REMARKS

Application No. 10/797,565

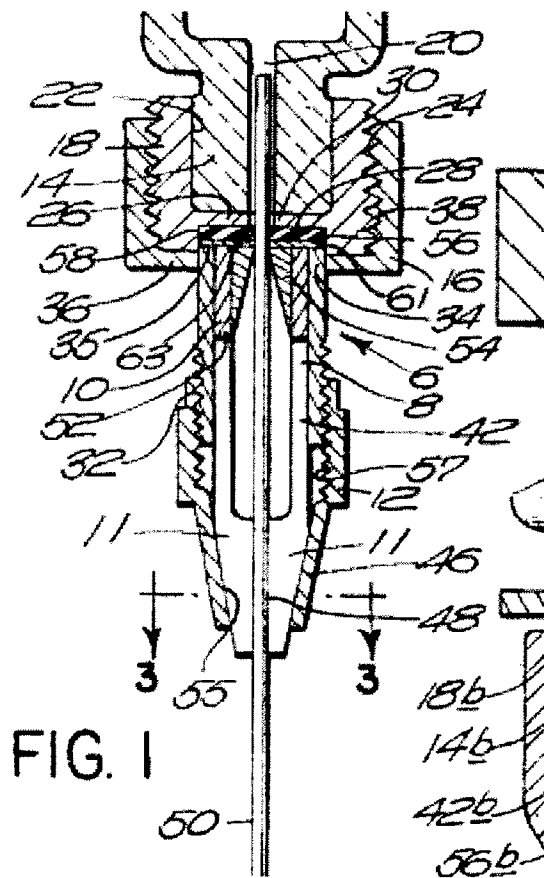
As shown in Myerson's FIG. 1, a portion of which is reproduced and enlarged below for convenience, Myerson's vise 8 and gripping jaws 11 (\approx the first hub assembly) do not extend along the front interior surface of end wall 36. Indeed, the assembly of vise 8, gripping jaws 11, and tube 10 is press fit into aperture 34 in end wall 36 (see column 3, lines 63-66). No part of vise 8, jaws 11, and tube 10 extends along the front interior surface of end wall 36.

Myerson's screw cap 12 (\approx the second hub assembly) does not have reinforcing structures that extend outwardly along and contact the front exterior surface of end wall 36. Indeed, screw cap 12 does not engage end wall 36 at all.

Consequently, Myerson's end wall 36 is not adjoined on the front interior surface by vise 8 and gripping jaws 11 (\approx the first hub assembly) or on the front exterior surface by screw cap 12 (\approx the second hub assembly).
